UNITED STATES PATENT AND TRADEMARK OFFICE

APPLICATION NO.	FILING DATE	FIRST NAMED INVENTOR	ATTORNEY DOCKET NO.	CONFIRMATION NO.
10/758,390	01/15/2004	Frederick Paul Renken	STL11265	5446
26861 7590 10/31/2007 SEAGATE TECHNOLOGY LLC INTELLECTUAL PROPERTY DEPT. - COL2LGL 389 DISC DRIVE LONGMONT, CO 80503			EXAMINER KAYRISH, MATTHEW	
			ART UNIT 2627	PAPER NUMBER
			MAIL DATE 10/31/2007	DELIVERY MODE PAPER

Office Action Summary

DETAILED ACTION

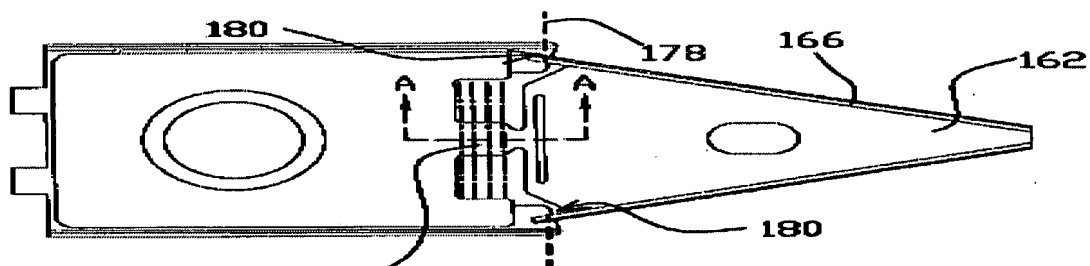
A closed (column 7, lines 21-42) aperture bounded by the bend member and the mounting region (figure 9B below); and

A load beam region with a damping material support structure (figure 9A, items 174 & 176) adjacent the bend member (figure 9A), the damping material support structure offset from the bend member and extending into the aperture (figure 9A, items 174 & 176 are in the aperture).

The strut is a plurality of struts, and in which the mounting region, the damping material support structure and the plurality of struts form boundaries of the aperture (figure 9B, 2 struts, mounting region and damping material support structure enclose aperture).

The strut is a plurality of struts, and in which the damping material support structure, the plurality of struts along with the proximal end of the load beam region form boundaries of an isolation aperture, the isolation aperture precludes interference by the damping material support structure with the plurality of struts (figure 9B, 2 struts, mounting region and damping material support structure enclose aperture).
